# Authorized Field Change

AFC G-06912

**Subject:** Inspect For Possible Missing Bolt at Rear Mount Pad

Model: 9200i, 9400i, 9900i

**Figure 1**

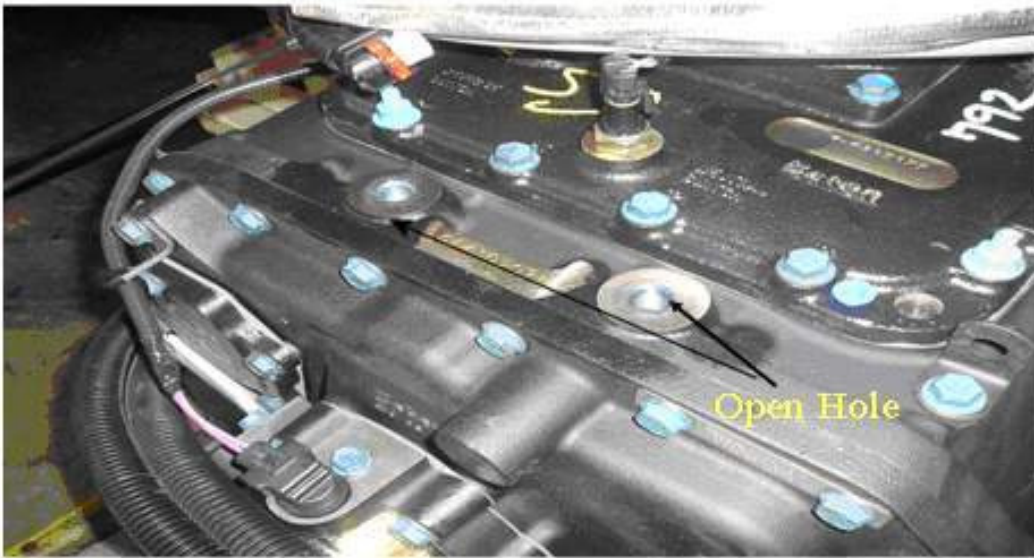
Possible oil leakage from the top right rear of the transmission due to missing rear mounting pad bolts.

This AFC applies to all 9200i, 9400i, 9900i models built at Chatham from 7/19/06 to 8/18/06 with the Fuller FR model 10 speed transmission. These can be identified by the blue color metric bolts on the rear cover.

1. Visually check transmission mounting pad for bolts.
2. If bolts are present and no signs of leak, release unit.
3. If bolts are missing, check transmission fluid level. If fluid is within 1 inch of fill plug, top off with correct fluid. Install M16x1.5 25.4 mm or shorter bolt in each hole. (Make sure to use sealant on bolt threads.) Torque bolt to 50 lbf-ft and release unit.
4. If bolts are missing and fluid level is lower than 1 inch below the fill plug or the fluid is contaminated with water, drain the fluid. Pull PTO cover and inspect gears for wear. If gears are not damaged, install PTO cover and fill with new fluid. Install M16x1.5 25.4 mm or shorter bolts in each hole. (Make sure to use sealant on bolt threads.) Torque to 50 lbf-ft and release unit.
5. If gear damage is found, repair as needed.
